Subject: Telecon Transmittal #8
Comanche Peak Steam Electric Station
Independent Assessment Program - Phase 4
Texas Utilities Generating Company
Job. No. 84056

Communications Report

Company:	Texas Utilities	<input type="checkbox"/> Telecon	<input checked="" type="checkbox"/> Conference Report
Project:	Comanche Peak Steam Electric Station Independent Assessment Program - Phase 4	Job No.	84056
		Date:	6/15/84
Subject:	Electrical Review	Time:	1:30 p.m.
	Conduit Sizing	Place:	G&H Offices
Participants:	P. N. Lalaji	of	G&H
	T. R. Martin		Cygn

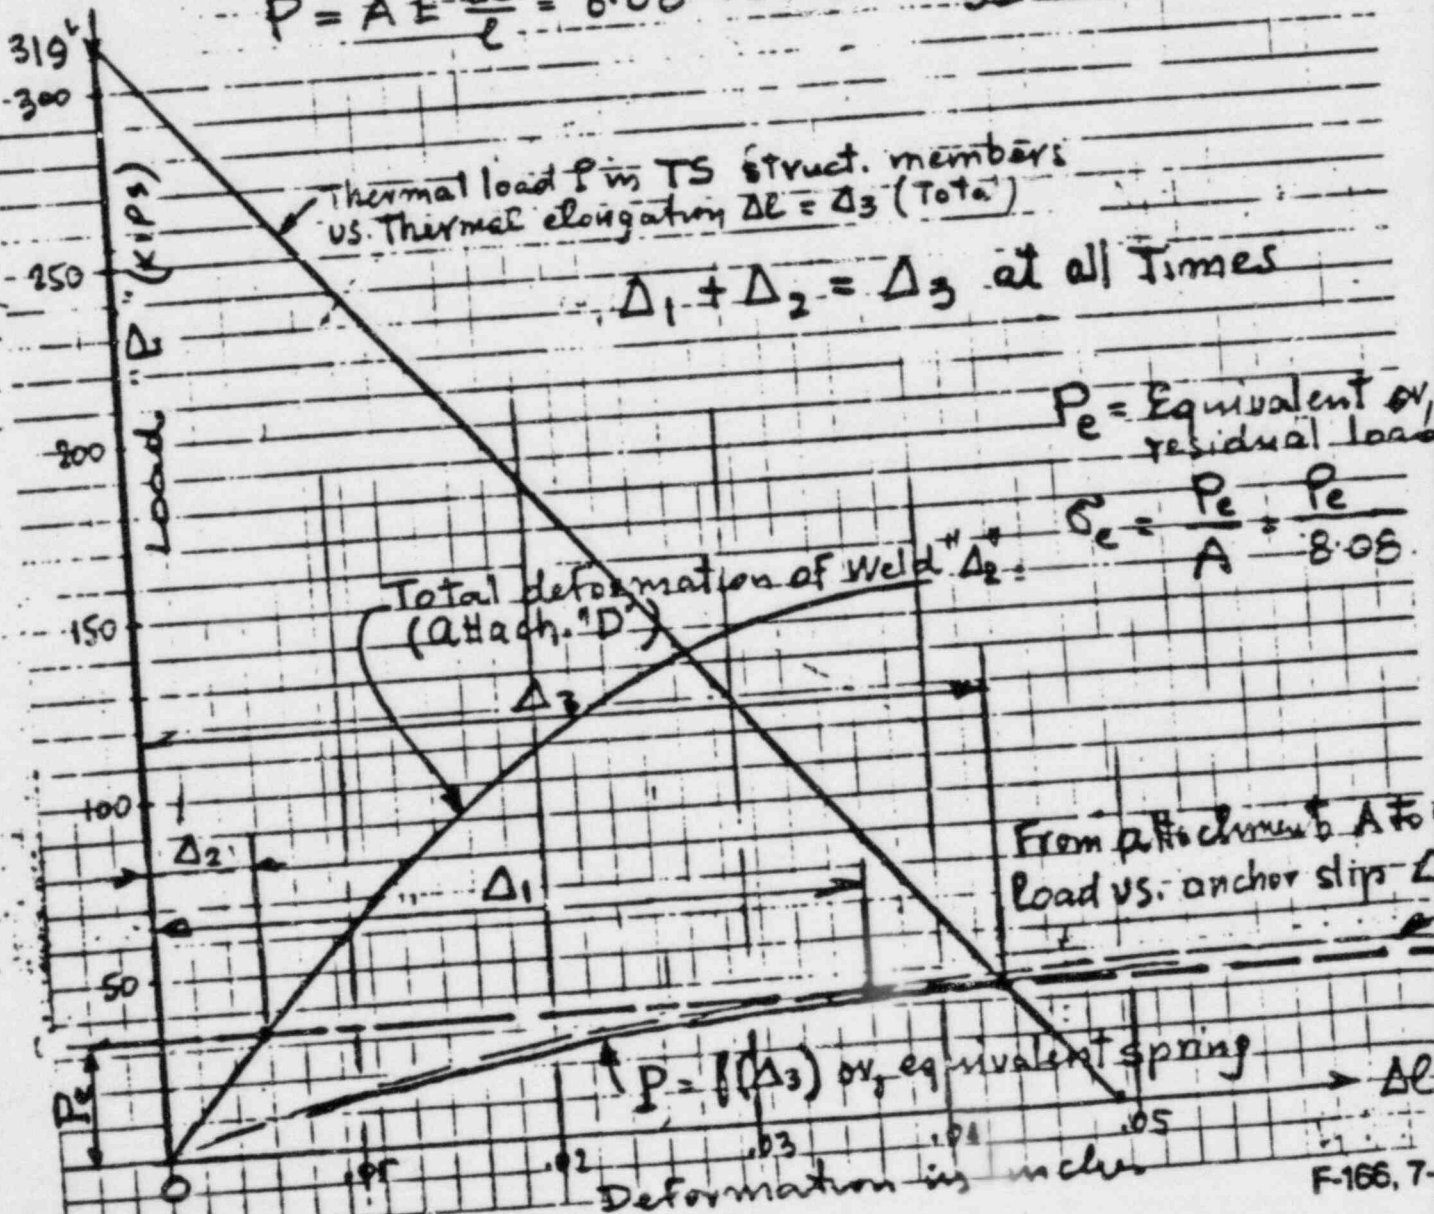
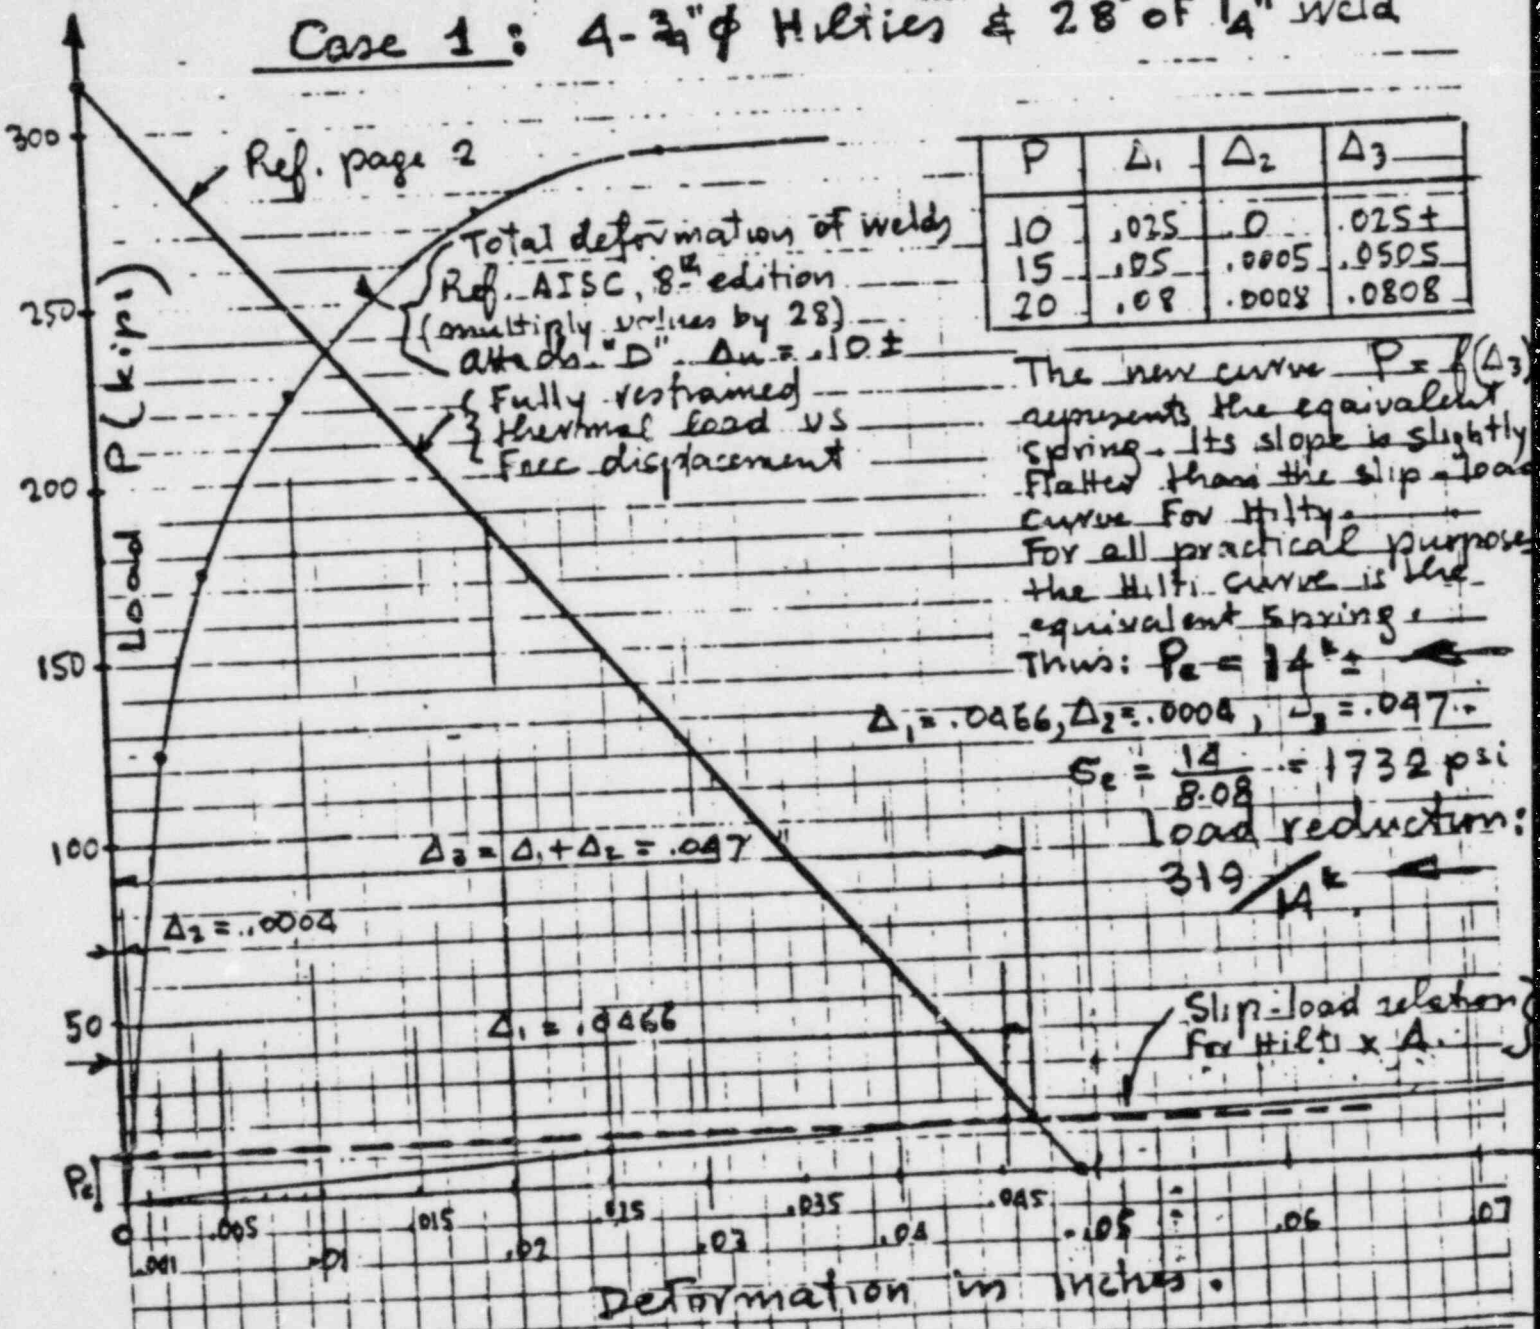
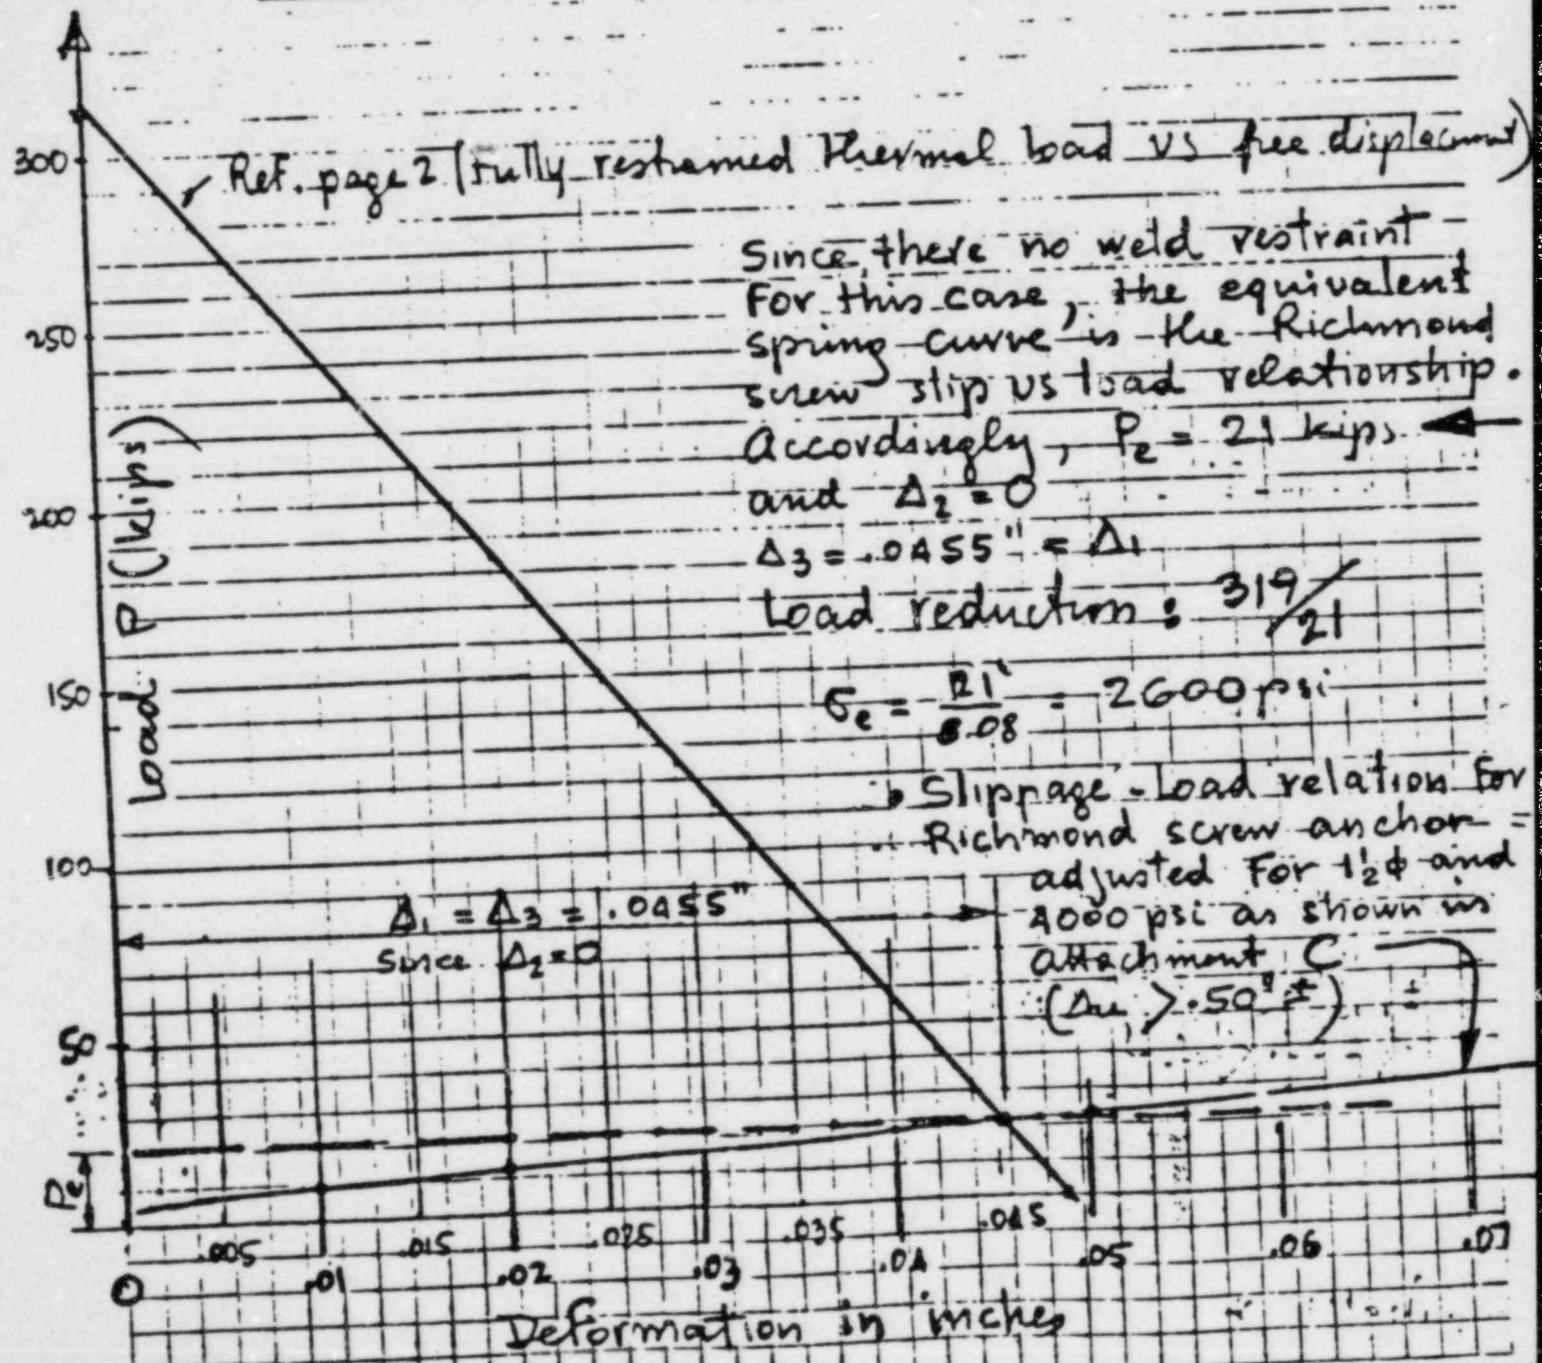
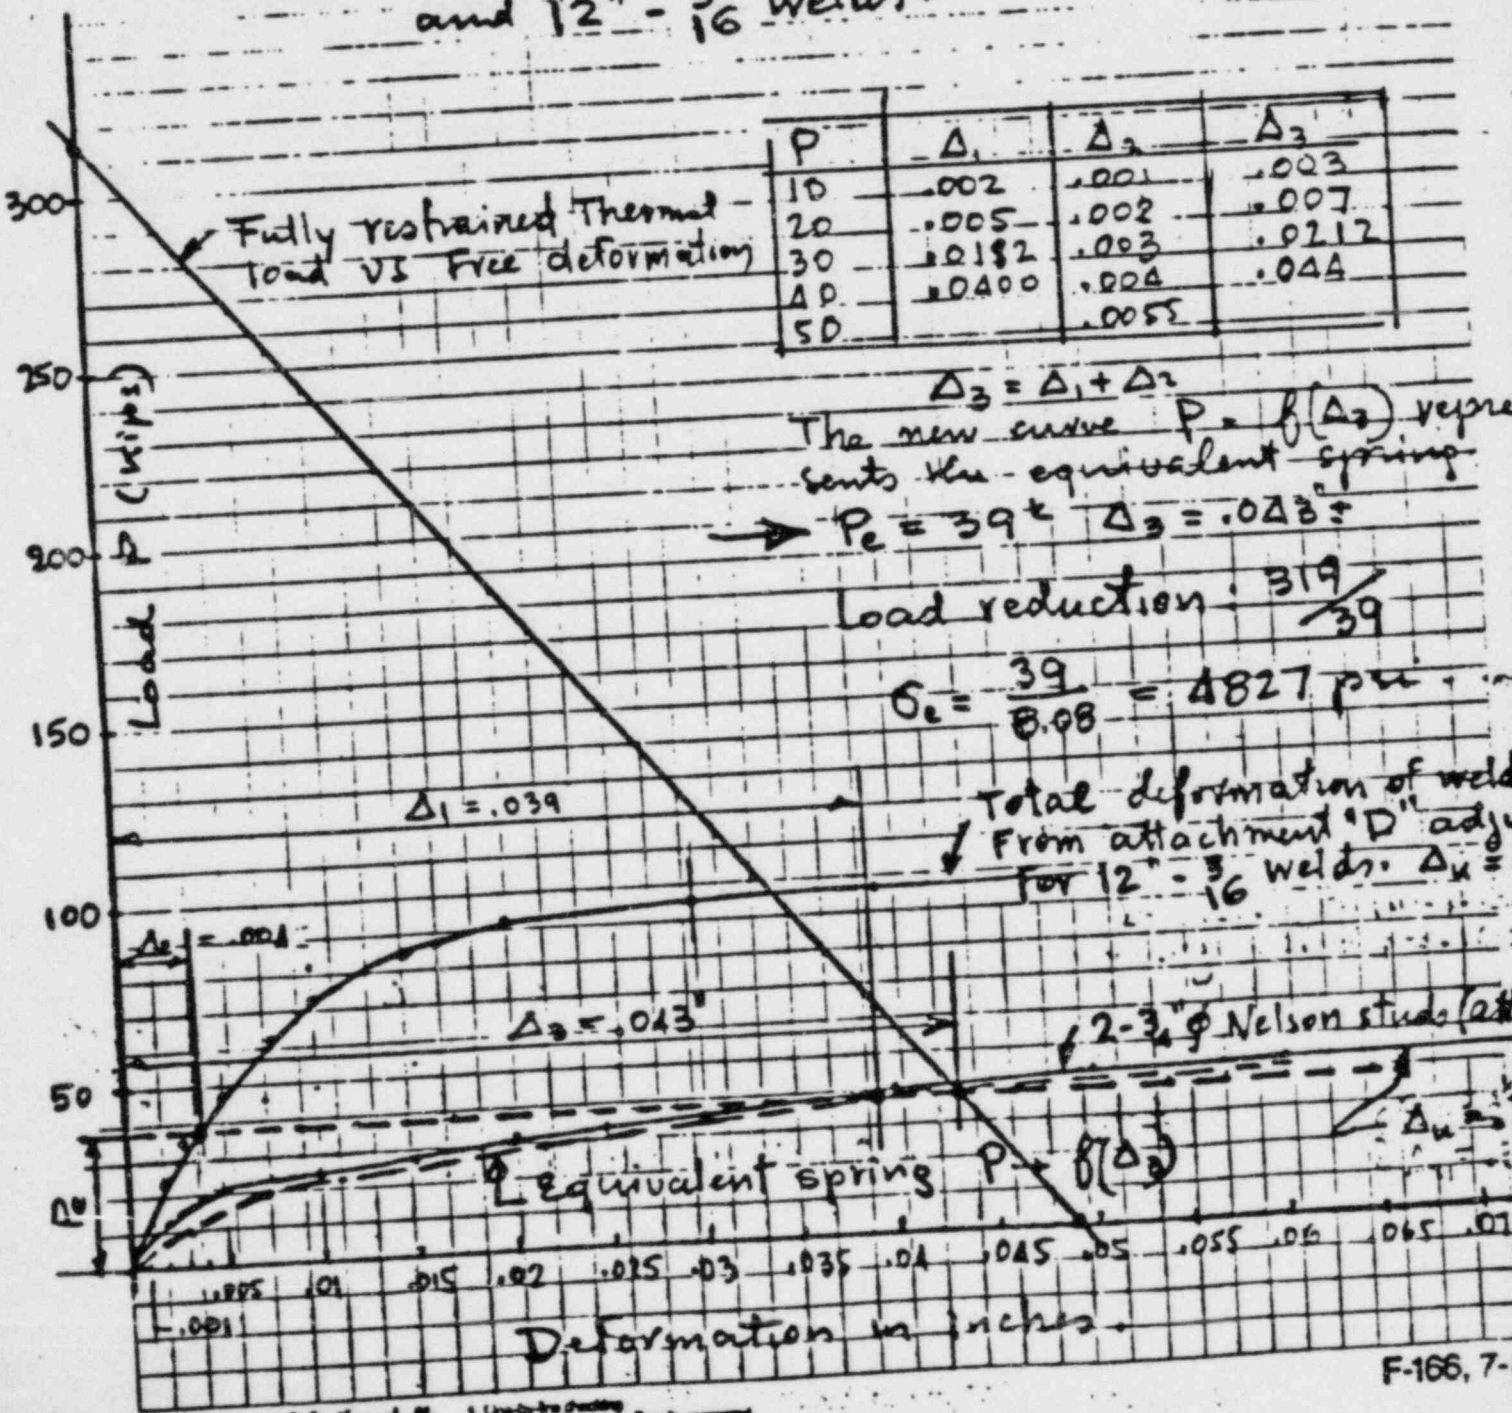
CYGNA's Question

Provide calculations or documentations on the acceptability of excluding thermal effects in the design of cable tray and conduit supports.

In response to an earlier ASLB question on thermal effects on pipe supports, a report titled, "Evaluation of LOCA Temperature Effects on Pipe Supports" was issued on August 26, 1982. The findings of this report are applicable to cable tray and conduit supports due to the similarities in support materials and support configurations. The report concluded that the thermal stresses are secondary and self-limiting and that the increase in stress due to thermal load T_a (Thermal loads generated by the postulated break) is small. Note that under service load conditions, T_o is used in the load combination in lieu of T_a in the factored load combination and T_o is much smaller than T_a , thus the thermal effects from T_o is even smaller.
